Questions and Answers

USDA Clayton Farm
Irrigation Project
Legend
ARS
Auto Parts Outlet - Raleigh
Castaways
Clemmons Educational State Forest
Crab Seafood House in clayton
DPC Baseball Academy
Pine Hollow Golf Club
RV Park
Speedway Gas Station
Starbucks Coffee Company
Way of Life Baptist Church
Base
Option
ARS Raleigh Clayton Experiment Station
Little Creek
Google Earth
1000 ft
N

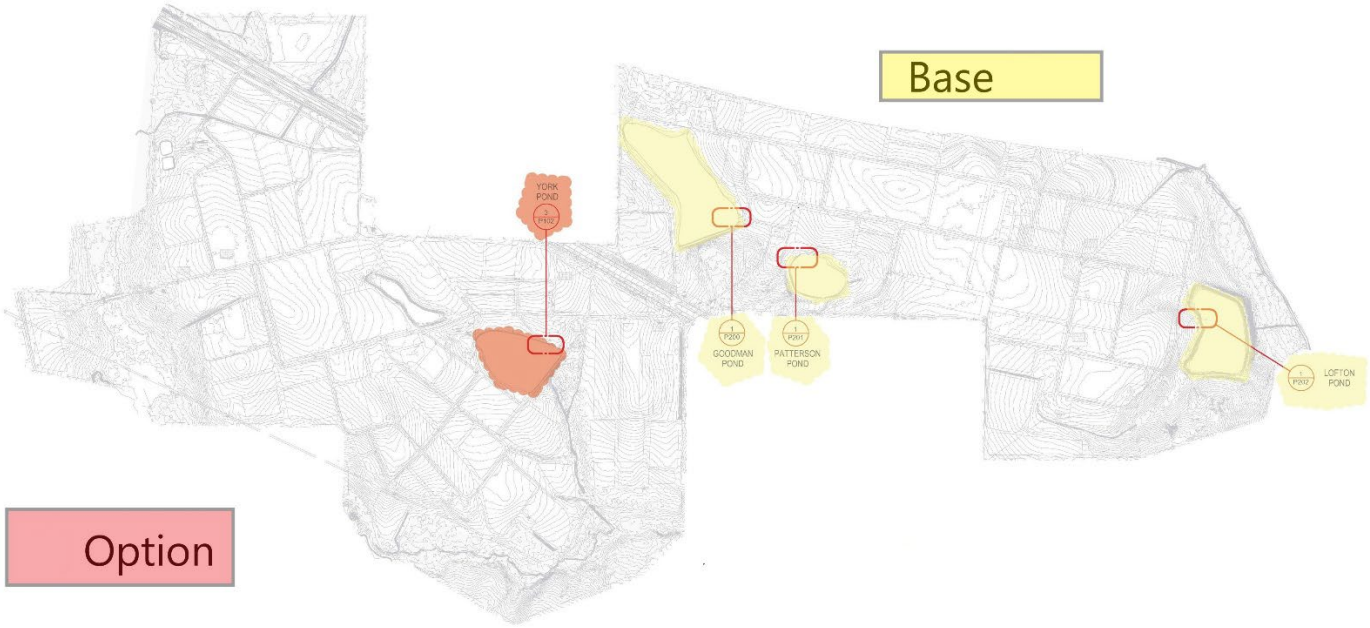
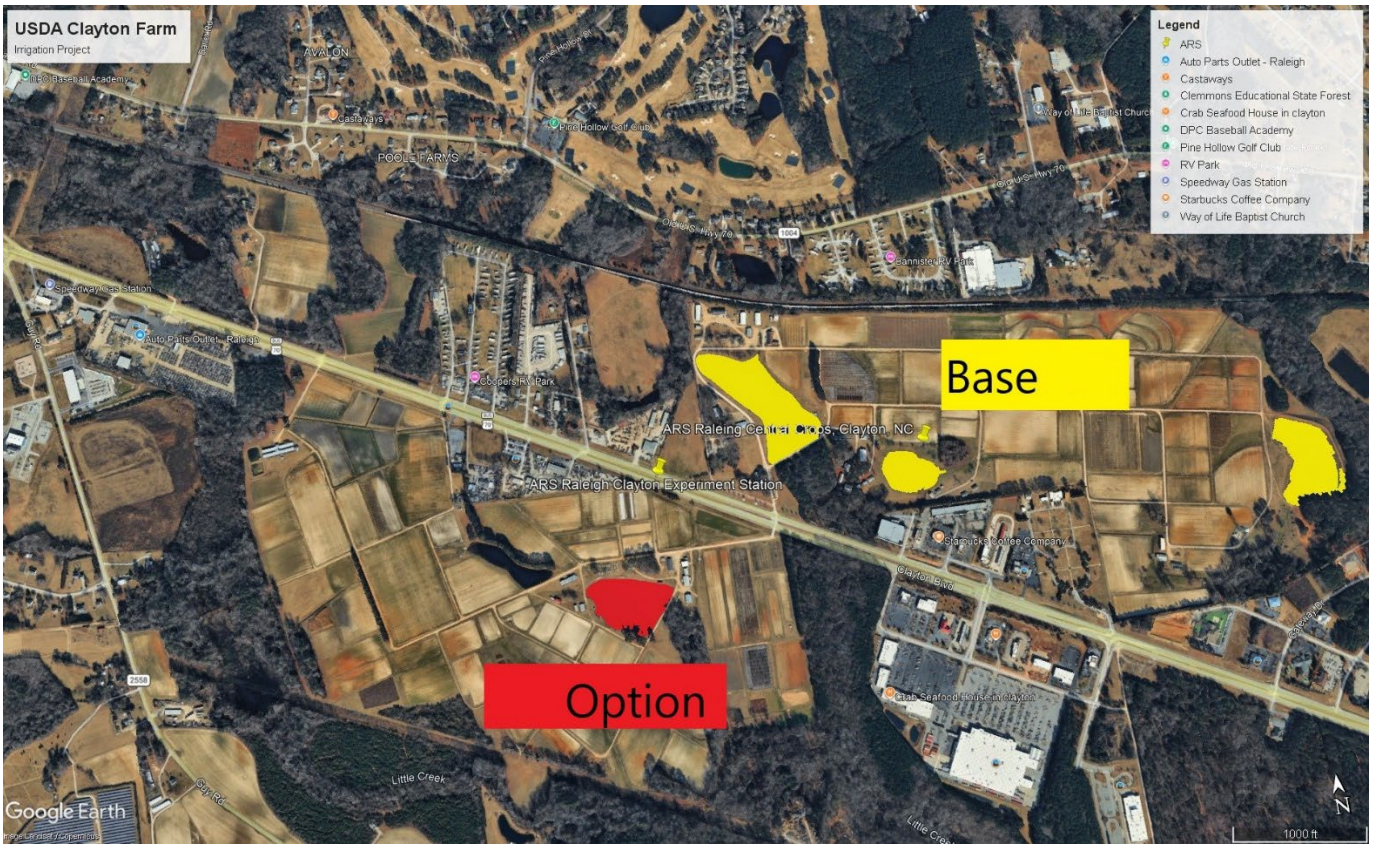
See mapping below to illustrate the updated schedule of items.
